**ORDINANCE NO. 594**

**AN ORDINANCE AMENDING THE WILSONVILLE COMPREHENSIVE PLAN BY ADOPTING THE AMENDED VILLEBOIS VILLAGE MASTER PLAN AS AN ANCILLARY DOCUMENT**

LP2005-02-00006

Figure 3

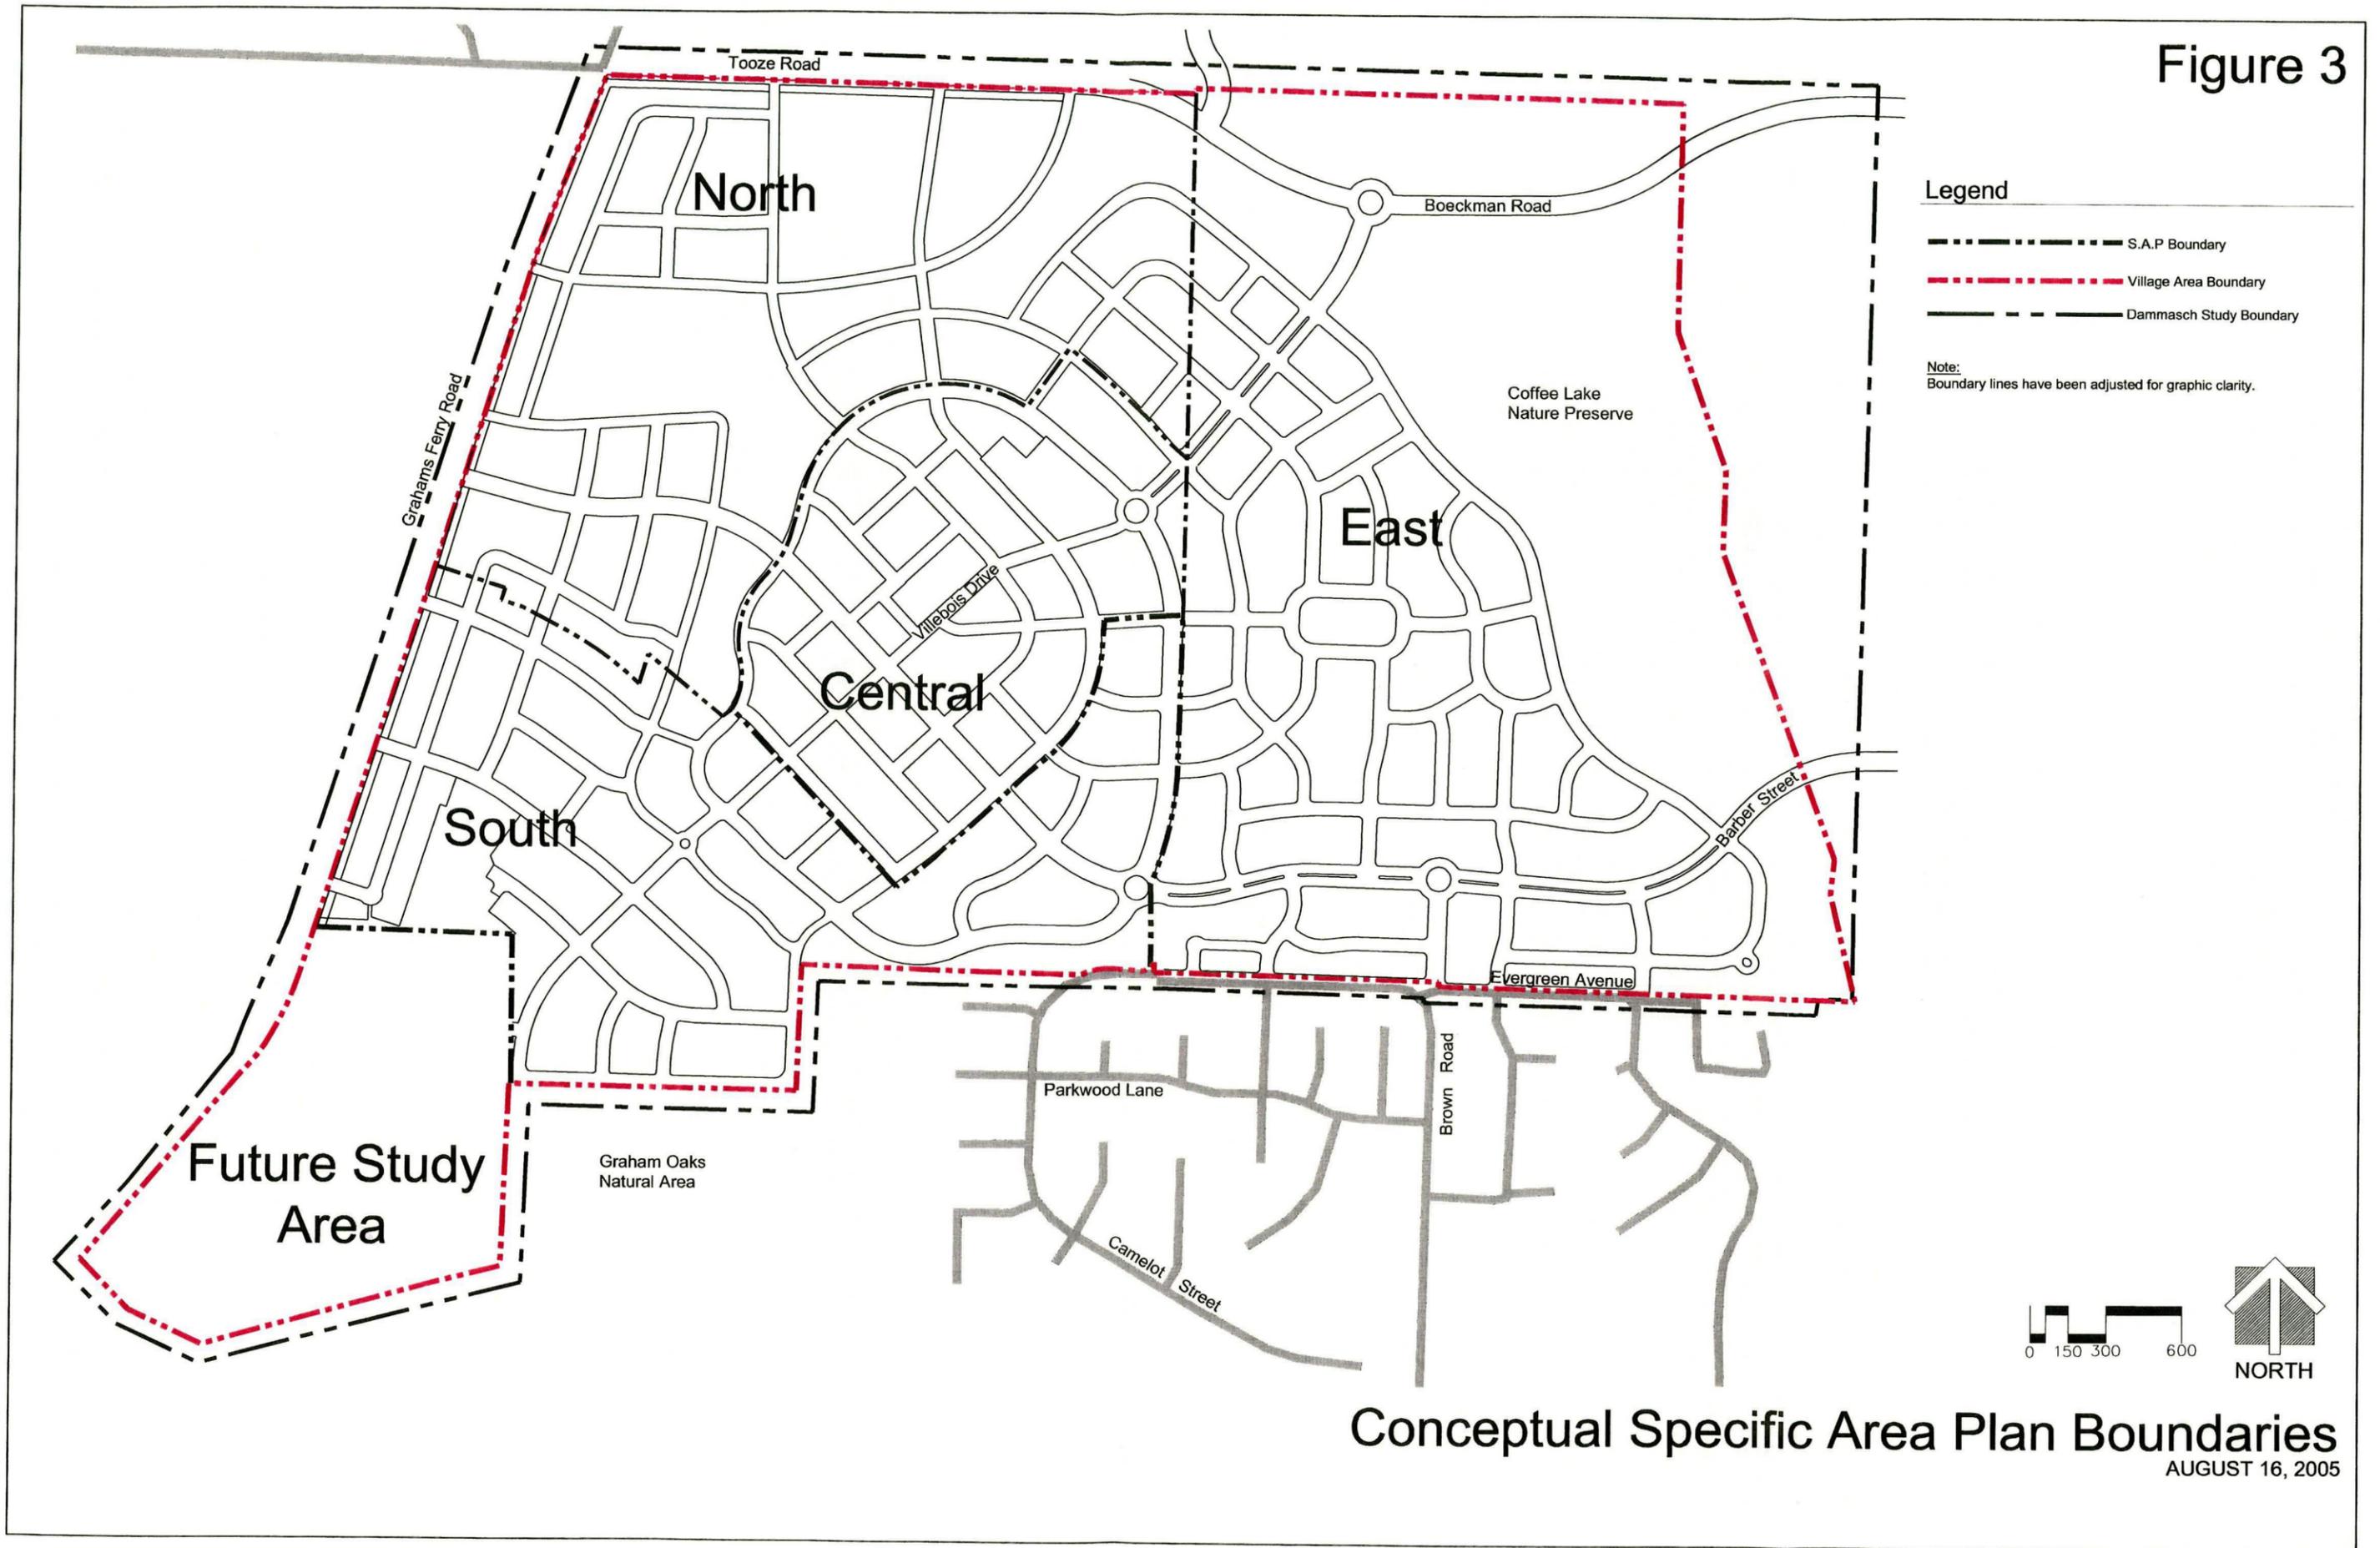
- Modified language related to the detailed siting of the elementary school in the north part of the project area.
- Figure 3: Updated street grid.
- Figure 4: Addition of a note that states the phasing dates are from the date of original approval in 2003.

# Figure 5

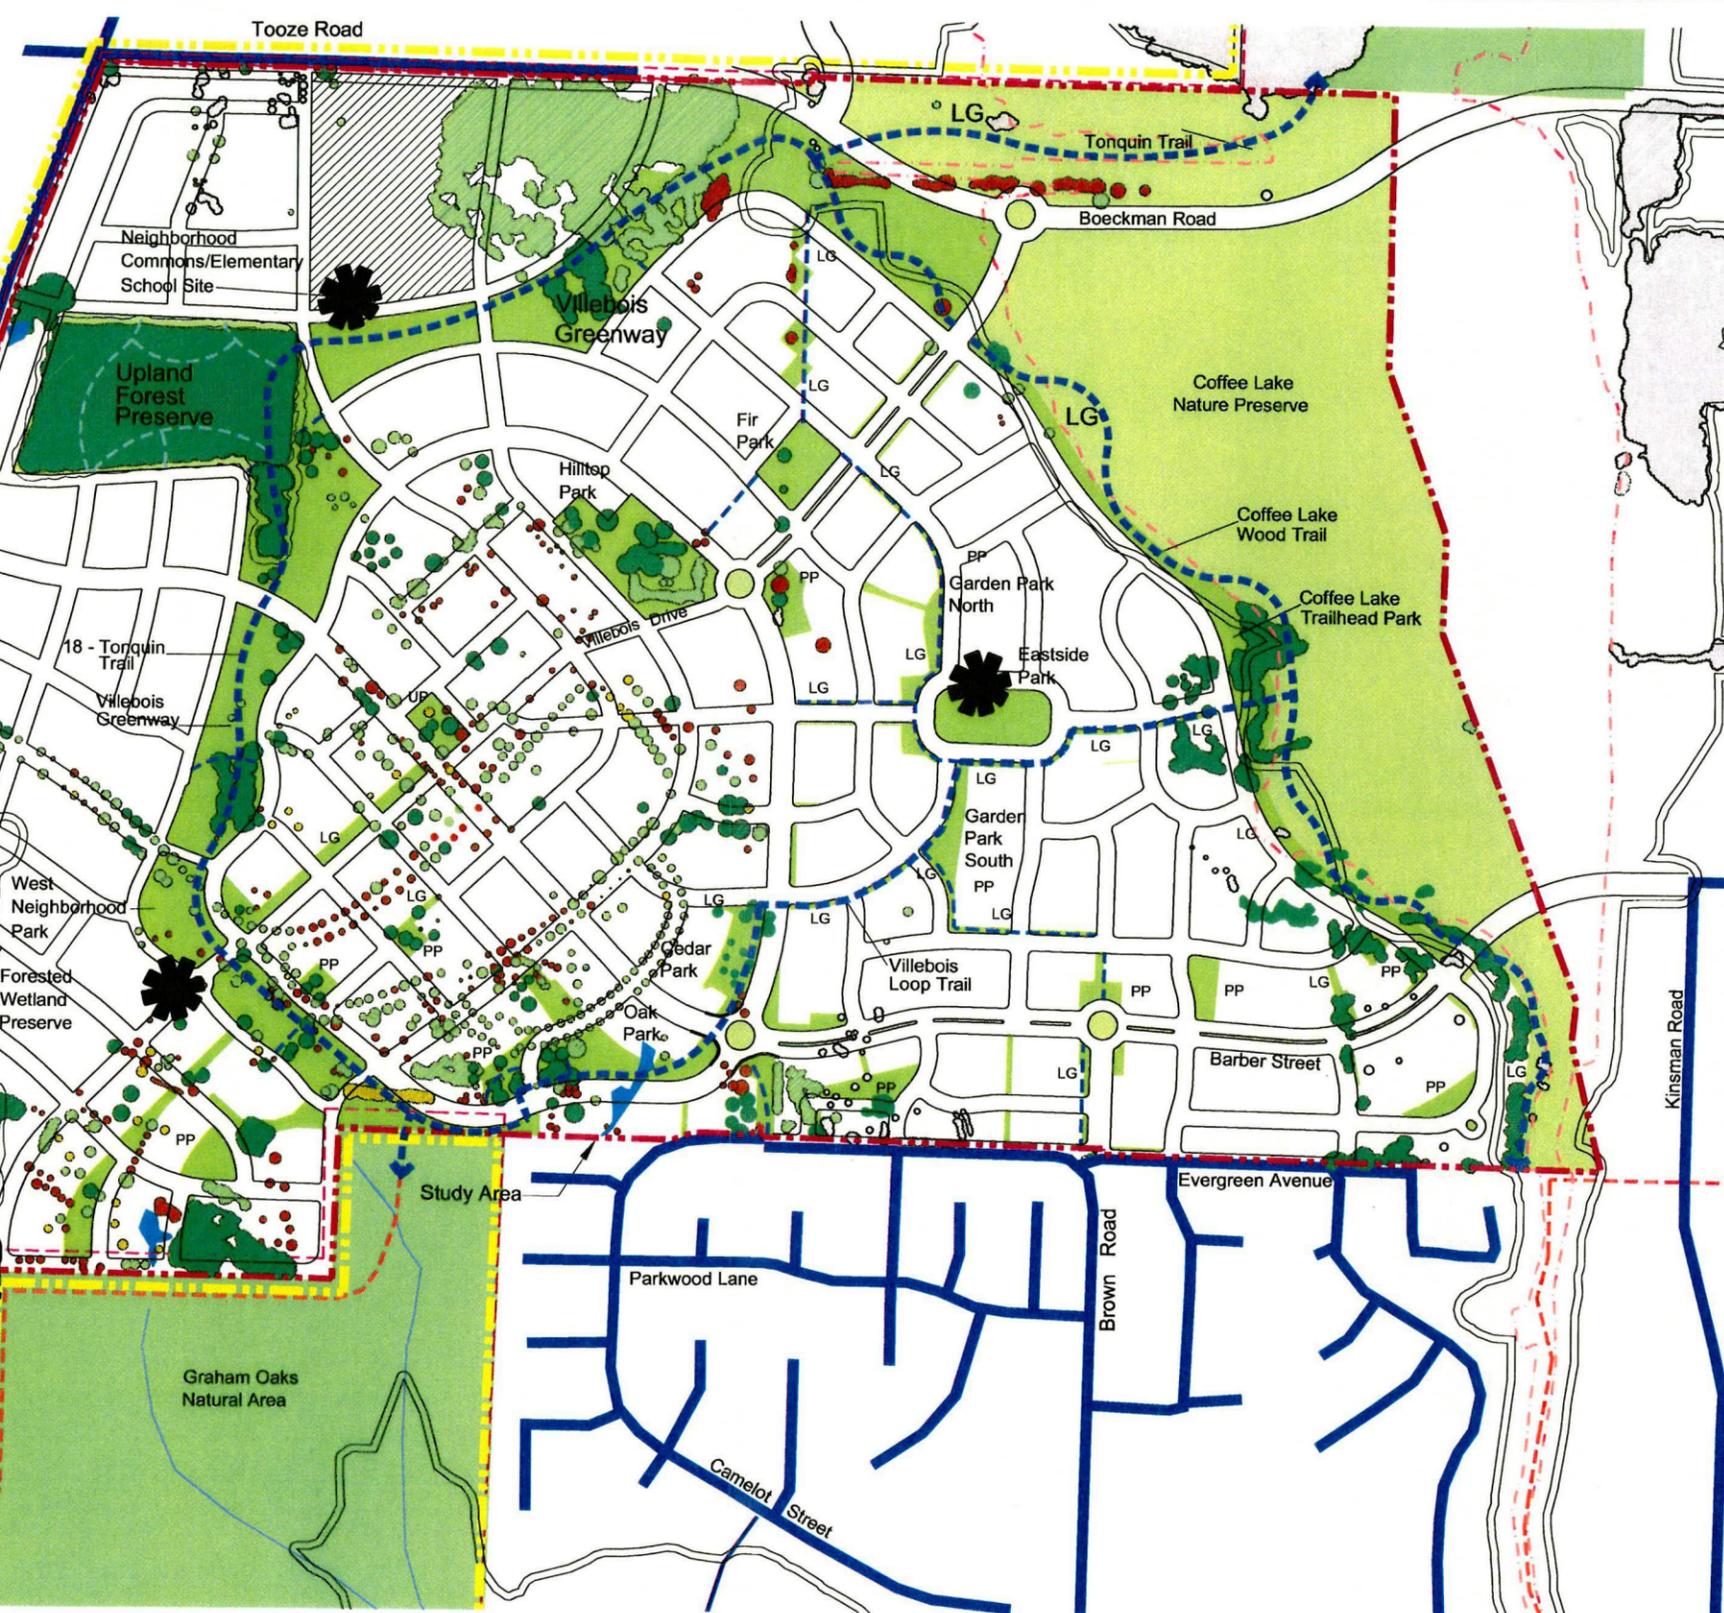
The major, minor, and nature trails/pathways shown on Figure 5 show minimal linkages to and from the public and private street system. Linkages should be provided between the point where

Staff response: The Master Planner has submitted a detailed draft parks and master plan and text to replace Figure 5 and text within Chapter 3. Staff is currently reviewing the draft with a goal for hearings at the Planning commission in February. In the meantime, staff and the various partners have finalized the Operations and Maintenance Agreement template setting forth maintenance duties for the various categories of parks and open space. The amendment in # 3 above adds an Implementation Measure with requirements for submittal.

Figure 6

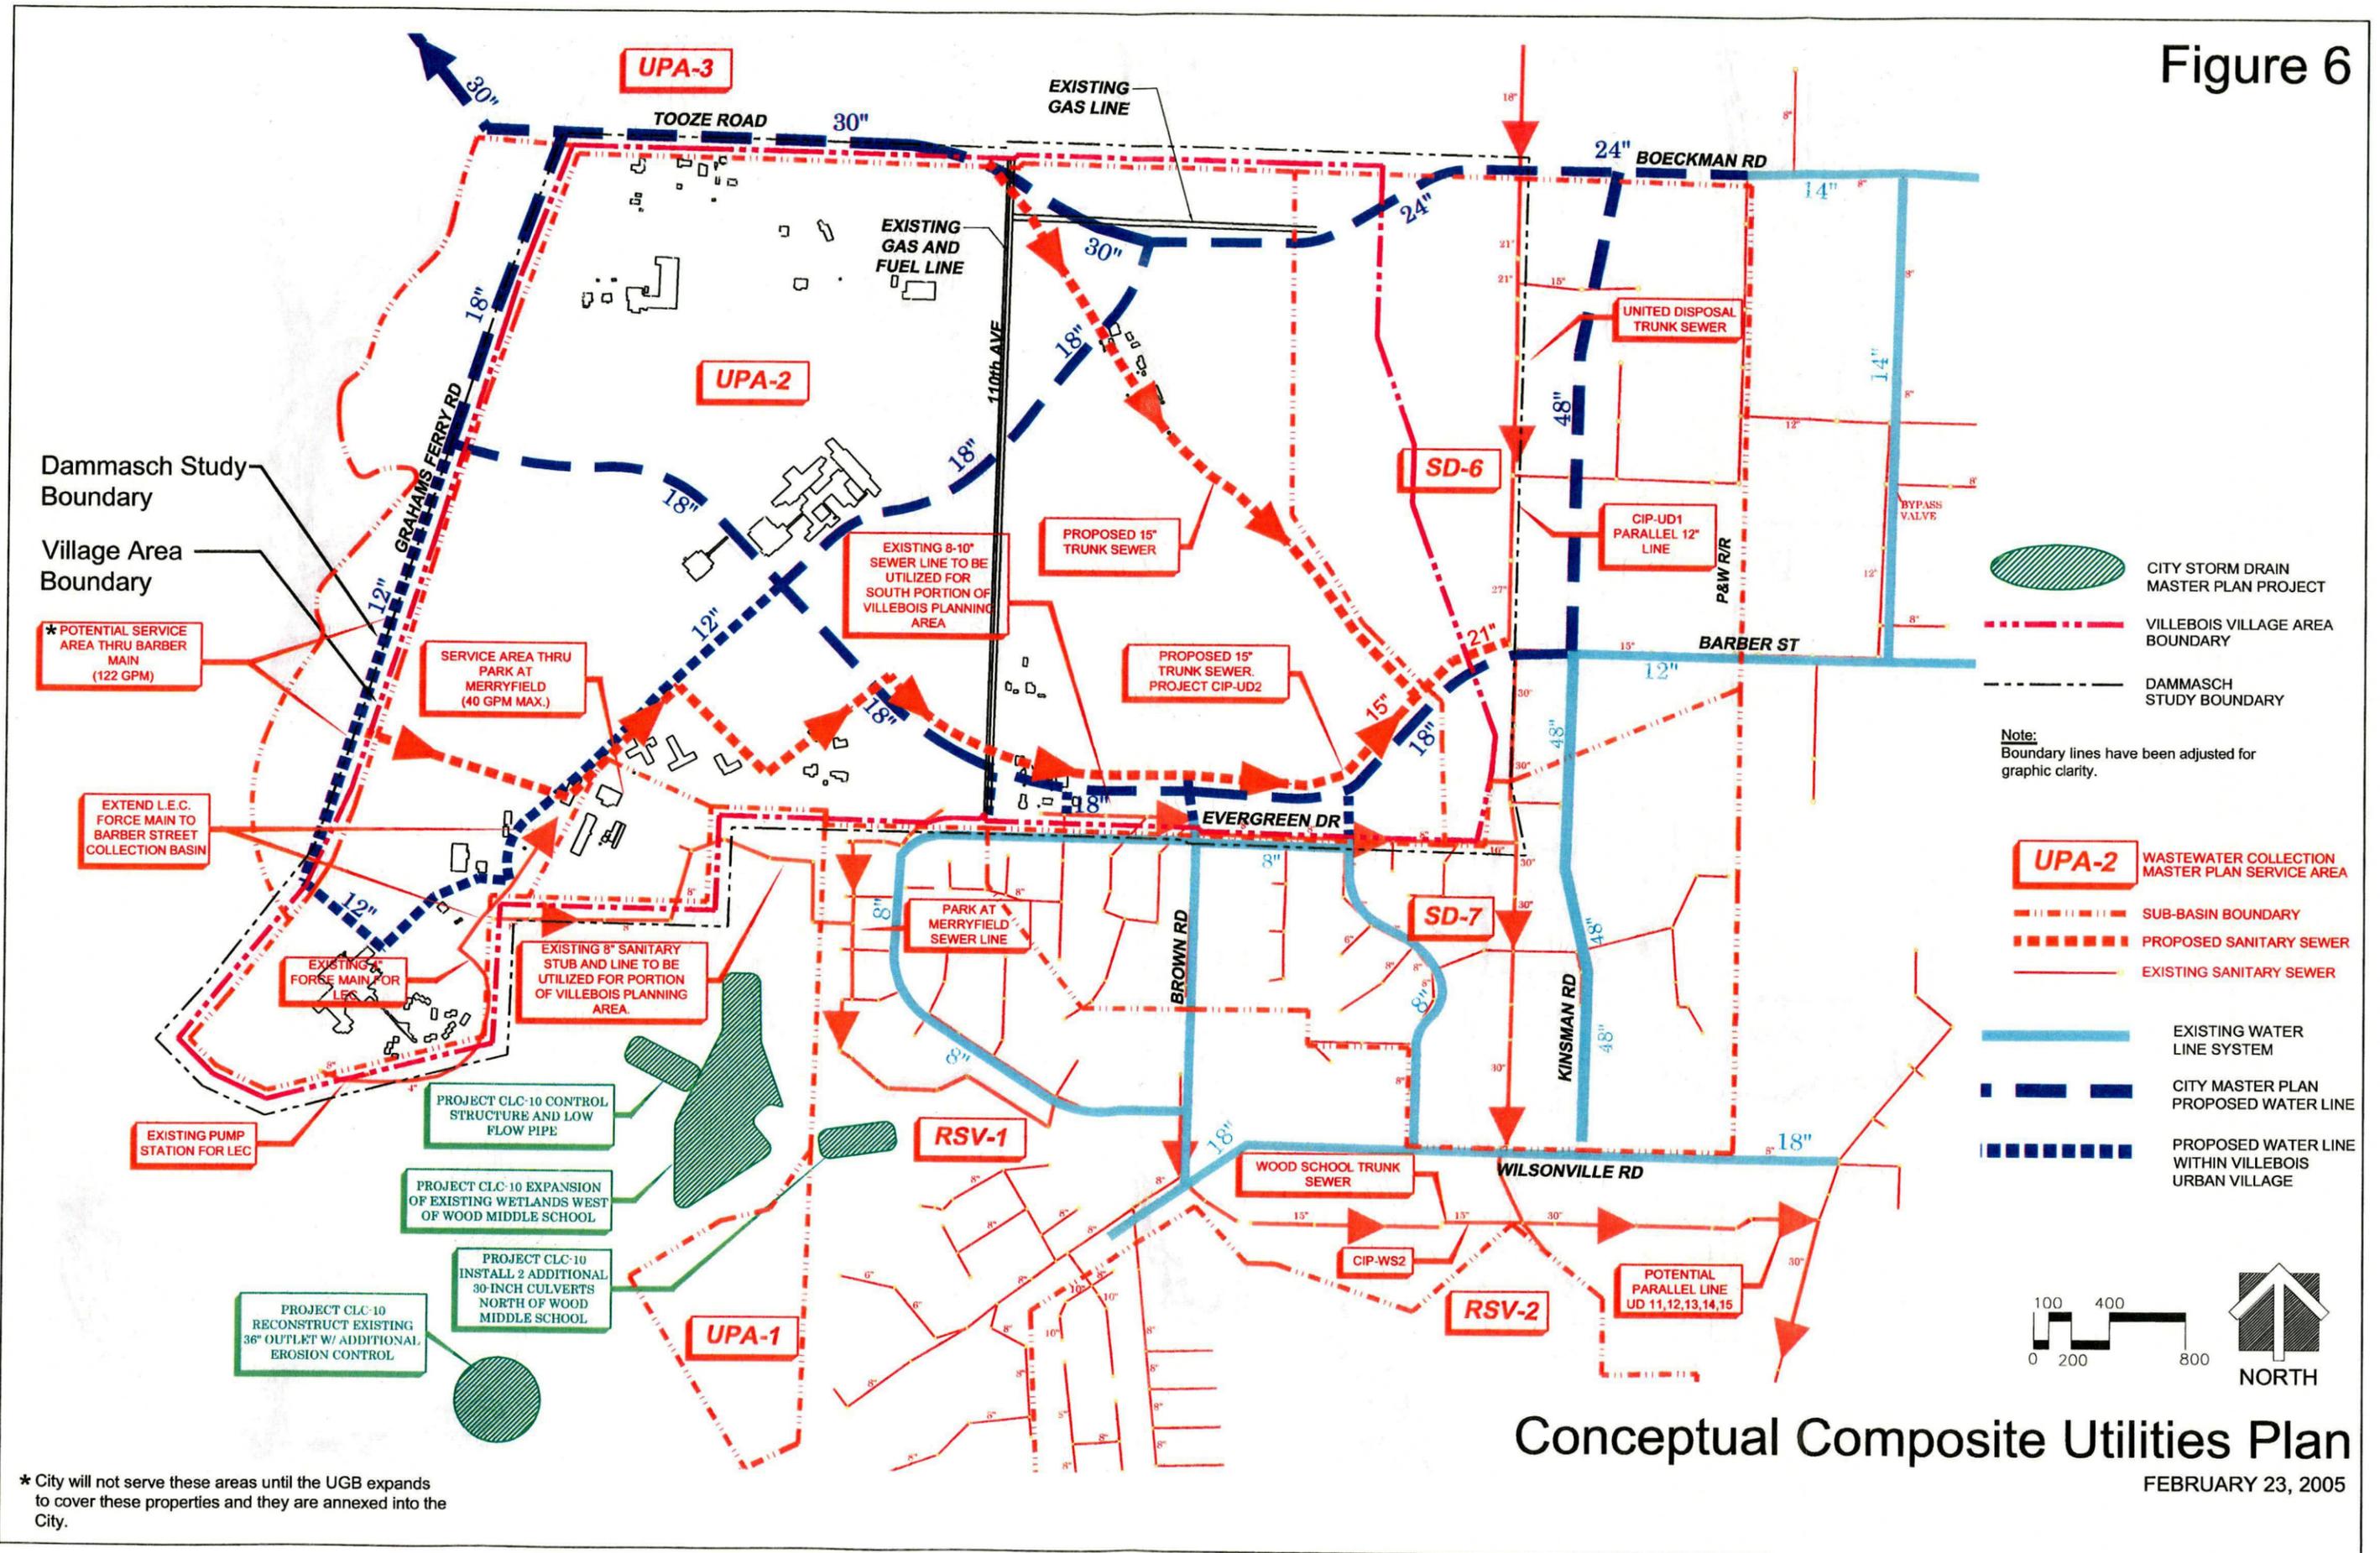
There are only minor changes proposed to the sanitary sewer section of Chapter 4 and Figure 6. They are related primarily to line location, flows and flow routing. Additional information is required to be provided by the applicant as part of the SAP Central application to determine the adequacy of the sewer capacity.
